Office Action Summary	Application No. 10/579,284	Applicant(s) SCHLEGL ET AL.	
	Examiner MARINA TIETJEN	Art Unit 3753

DETAILED ACTION

8. Claim 11-17, 19, 24-28,30-31 are rejected under 35 U.S.C. 103(a) as being unpatentable over Larson et al. (U.S. Pat. No. 5,413,073) in view of Schwaiger (DE 3625590) further in view of Leiber (WO 99/05397).

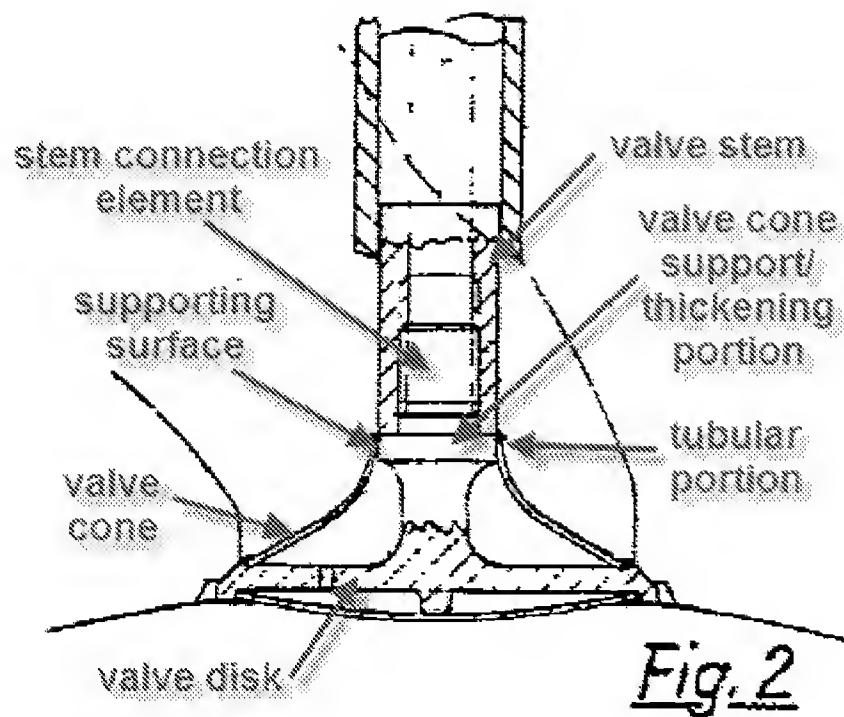
Schwaiger teaches a valve wherein a valve stem (see labeled fig. 2 below) is connected to a stem connection element (see labeled fig. 2 below) formed on a valve disk (see labeled fig. 2); wherein a valve cone support (see labeled fig. 2 below) is located at a distance from the valve disk and provided in a hollow space of a valve cone, the valve cone support being located on the stem connection element and projecting above the flat side; wherein the valve cone support includes at least one supporting surface (see labeled fig. 2 below) bearingly contacting an inner wall region of the valve cone; wherein a contour of the supporting surface complements the inner wall region; wherein the valve cone-support is formed by a thickening (as shown in fig. 2) on the stem connection element; and wherein the valve cone has at a smaller diameter end a tubular projection (see labeled fig. 2) for guiding through the valve stem or the stem connection element; wherein the valve cone-support (labeled fig. 2) forms a centering or supporting seat for the valve cone; wherein the valve cone, the valve disk and the valve stem are shaped such that the valve cone is capable of sliding over the valve stem so

the end face of the end of greater diameter of the valve cone is brought into contact with the valve disk after the valve disk is connected to the valve stem; wherein the stem connection element (labeled fig. 2) is arranged on the valve disk to fix a vertical position of the valve cone relative to the valve disk as the end face of the end of greater diameter of the valve cone is brought into contact with the valve disk; wherein the stem connection element (labeled fig. 2) is shaped such that the valve cone is capable of sliding over the stem connection element so the end face of the end of greater diameter of the valve cone is brought into contact with the valve disk after the valve disk is connected to the stem connection element; and wherein the stem connection element (labeled fig. 2) is shaped such that the valve cone, the valve disk and the stem connection element are capable of being aligned with each other before the valve cone, the valve disk and the stem connection element are materially connected, for the purpose of providing means for adding rigidity and structural support for the hollow valve cone and for the purpose of providing the ability for the valve disk and cone to be removable from the valve stem, and therefore replaceable.

Figure 3

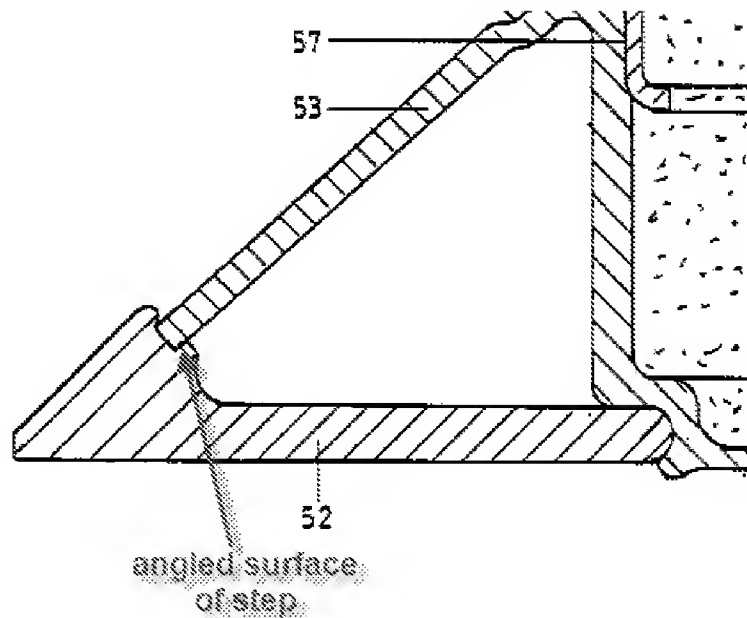
Leiber teaches a valve disk wherein the step (see labeled fig. 3) is clearly angled for the purpose of the step providing a better seating surface that contours the valve cone.

It would have been obvious to one having ordinary skill in the art at the time the invention was made to further modify Larson's invention such that the step is clearly angled, as taught by Leiber, for the purpose of the step providing a better seating surface that contours the valve cone.
